OYSTER CREEK NUCLEAR GENERATING STATION, UNIT NO. 1

AMENDMENT TO PROVISIONAL OPERATING LICENSE

Amendment No. 16
License No. DPR-16

ATTACHMENT TO LICENSE AMENDMENT NO. 16

FUEL CLADDING INTEGRITY SAFETY LIMIT

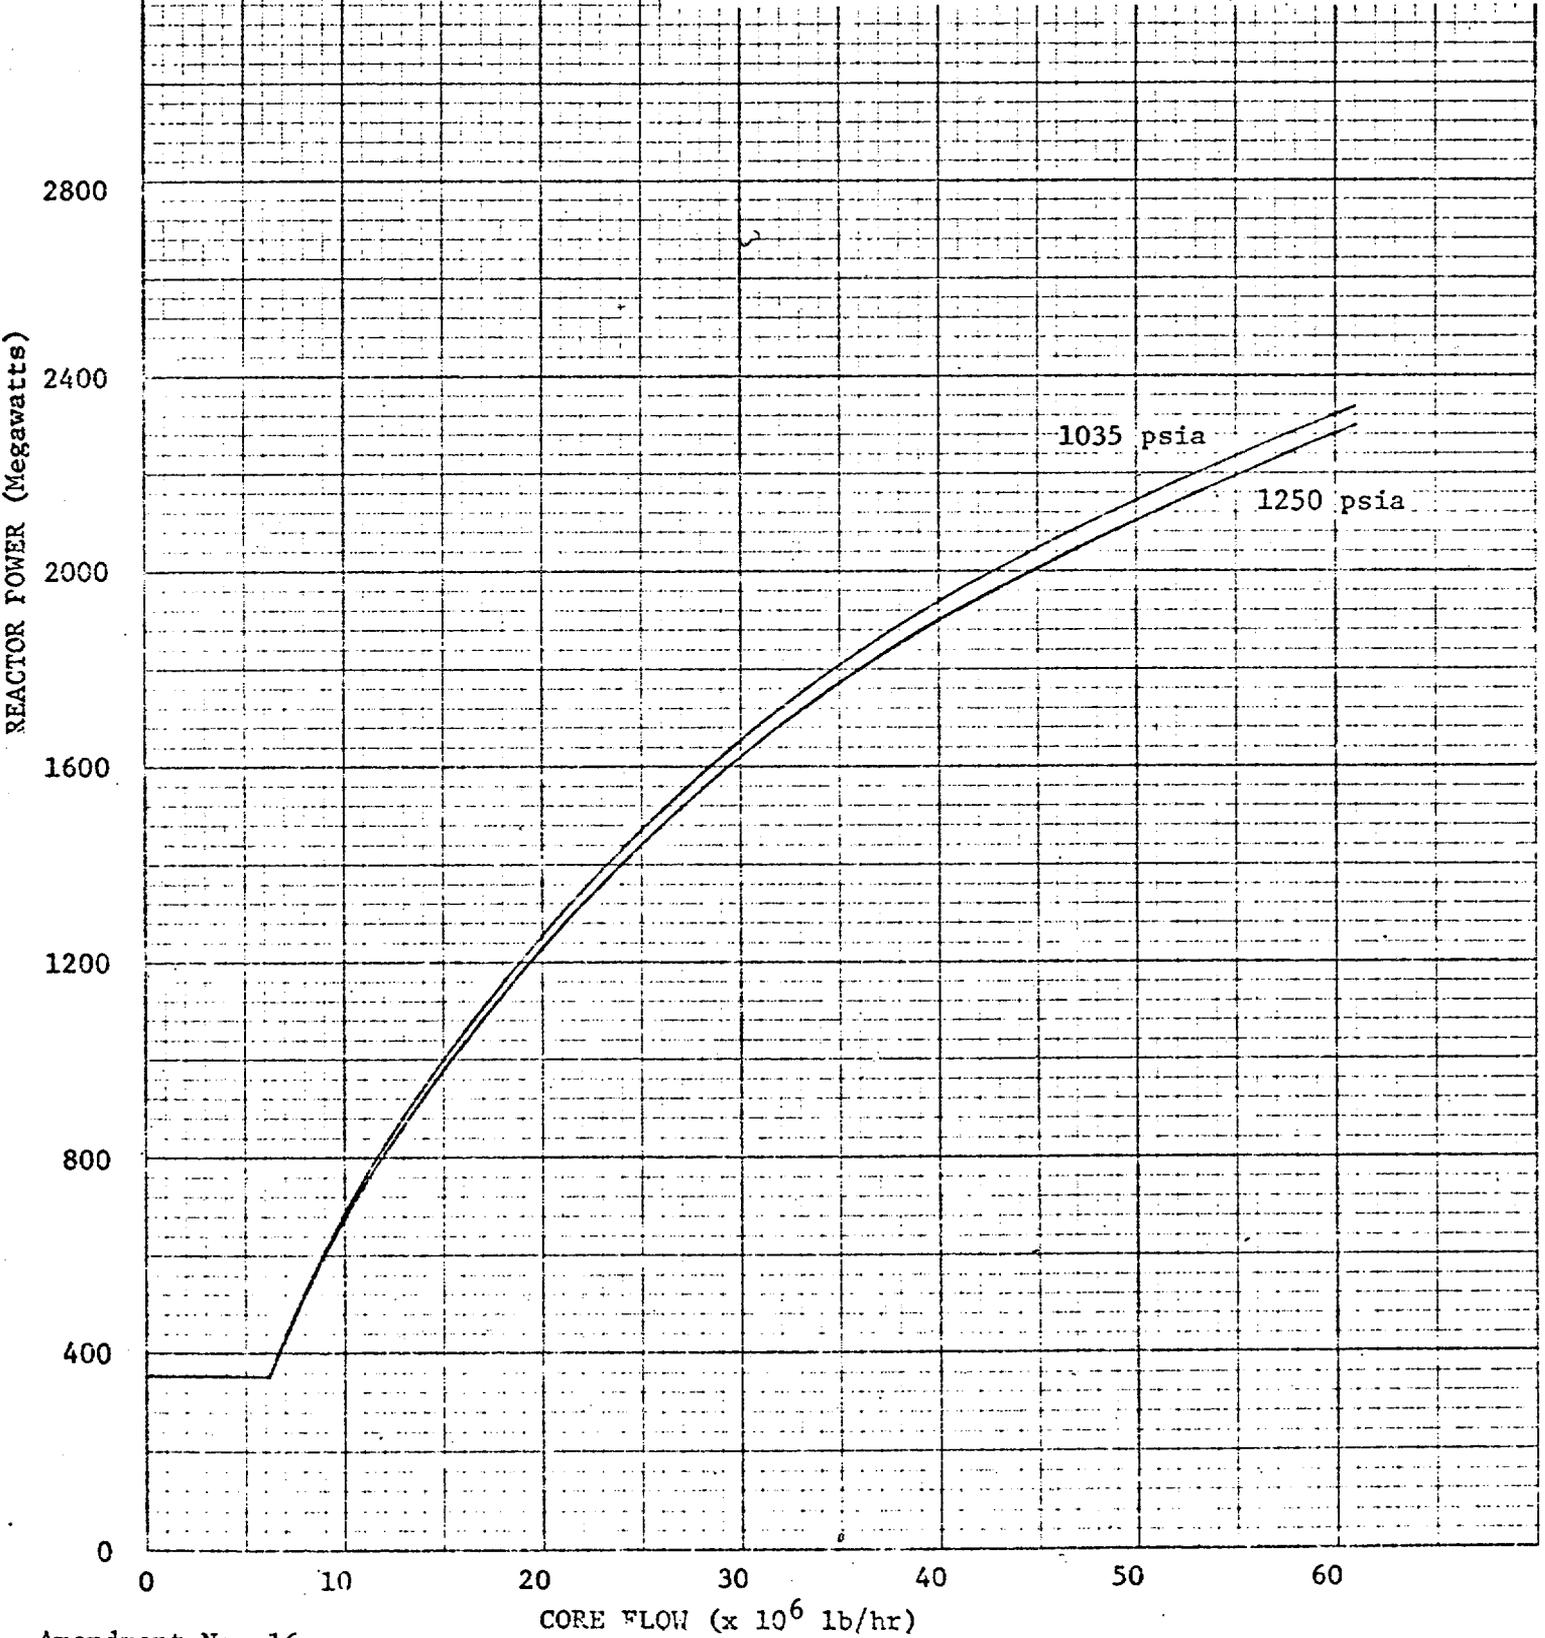
The results of analyses using the XN-2 critical power correlation indicate that a minimum critical power ratio (MCPR) of 1.32 assures with 95 percent confidence that there is more than 95 percent probability of avoiding boiling transition. This safety limit MCPR applies to both 7x7 and 8x8 fuel. However, it was determined that a 1% increase in MCPR is required to account for the four inert rods in 8x8 fuel assemblies. Thus, the safety limit MCPR is taken as 1.34 for the 8x8 fuel. It is concluded that the proposed fuel cladding integrity - MCPR safety limits of 1.32 for 7x7 fuel and 1.34 for 8x8 fuel (with four inert rods) are acceptable to prevent degraded heat transfer conditions. MCPR operating limits are established in order that, during abnormal operational transients, the MCPR's remain above the safety limits and, therefore, nucleate to film boiling transition is avoided if such transients should occur. The MCPR operating limits in effect provides additional margin to avoid boiling transition during normal steady state conditions thereby providing greater assurance of fuel clad integrity.

FIGURE 3.10-1

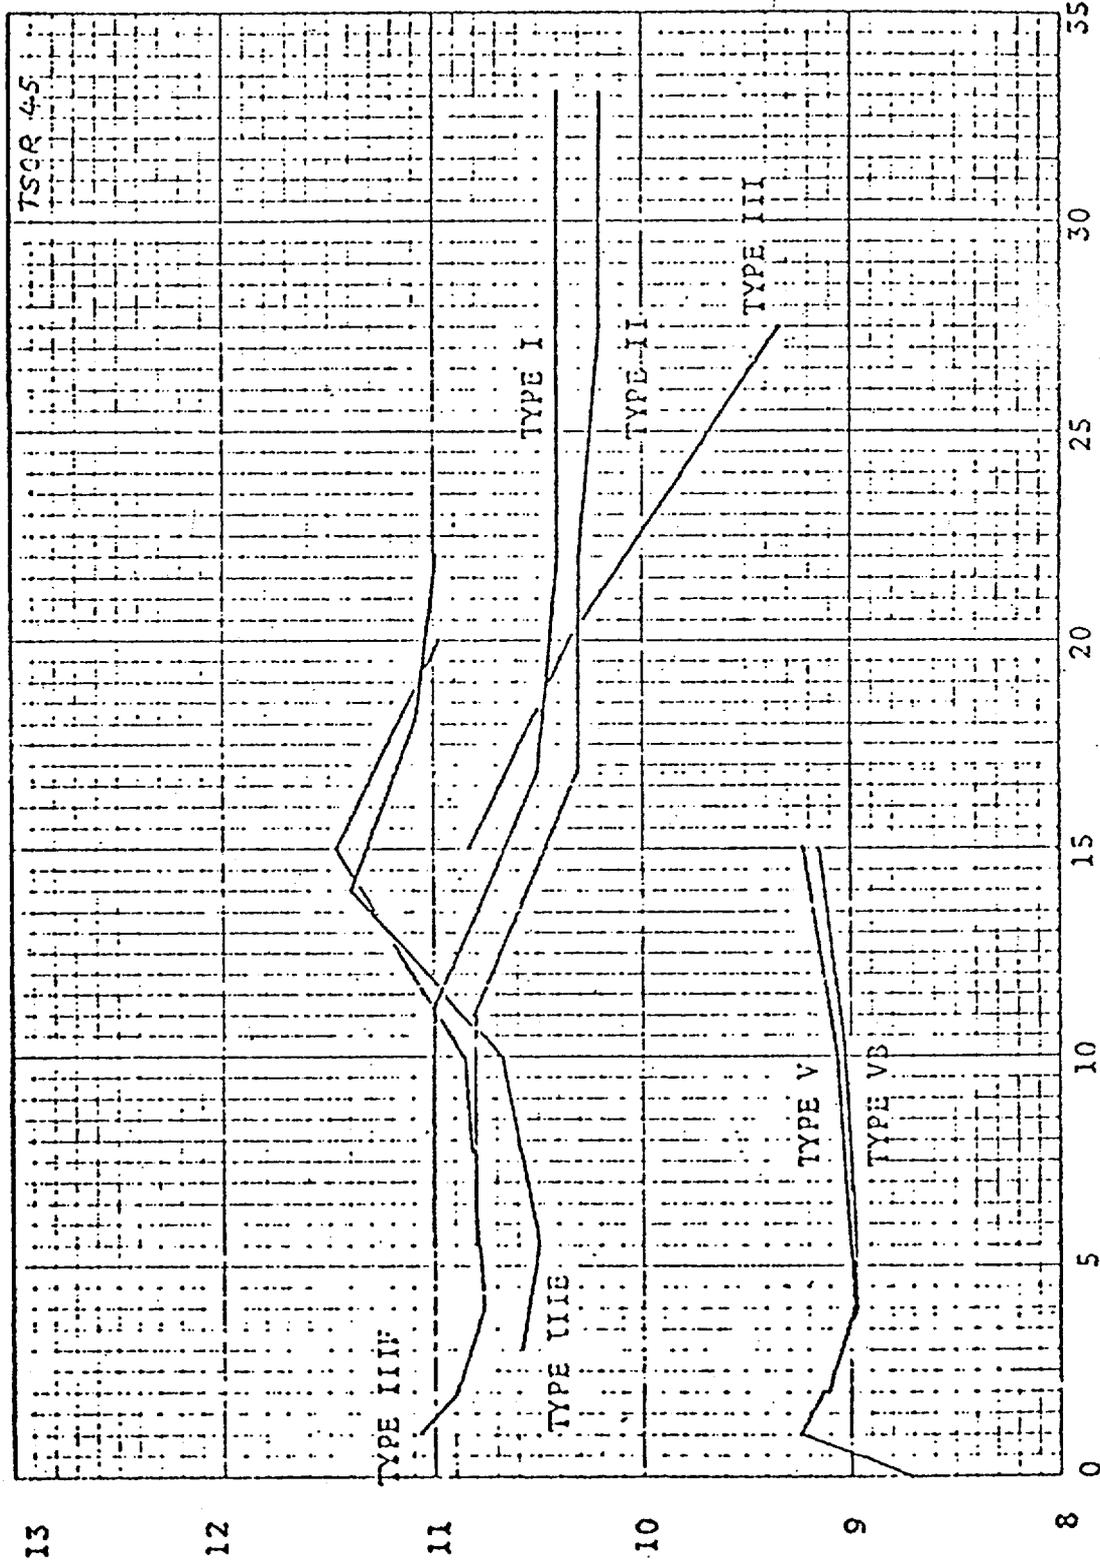
With respect to the increased MAPLHGR for types V and VB fuel shown in revised figure 3.10-1 of the technical specifications, the staff has concluded that the Exxon Nuclear Company Topical Reports "Spray Cooling Heat Transfer Phase 1 Test Results ENC - 8x8 BWR 60 and 63 Active Rods" and Supplements dated September 1975, and October 1975 that were approved by NRC on May 17, 1976, ⁽¹⁾ are an acceptable reference to justify use of the full "Appendix K" specified spray coefficients for ENC 8x8 fuel in the Oyster Creek reactor.

We agree with the Jersey Central Power and Light Company (JCP&L) statement that use of the new spray coefficients will not change the worst break location, size, or associated single failure ⁽²⁾. Therefore, reanalysis of the limiting 0.50 ft² break at the listed exposures ⁽³⁾ constitutes an acceptable ECCS analysis meeting all requirements of Appendix K to 10 CFR 50, and we approve operation of the Oyster Creek Reactor up to the Maximum Average Planar Linear Heat Generation Rate (MAPLHGR) limits resulting from those reanalyses utilizing the full Appendix K specified spray coefficients as shown in revised figure 3.10-1 of the technical specifications.
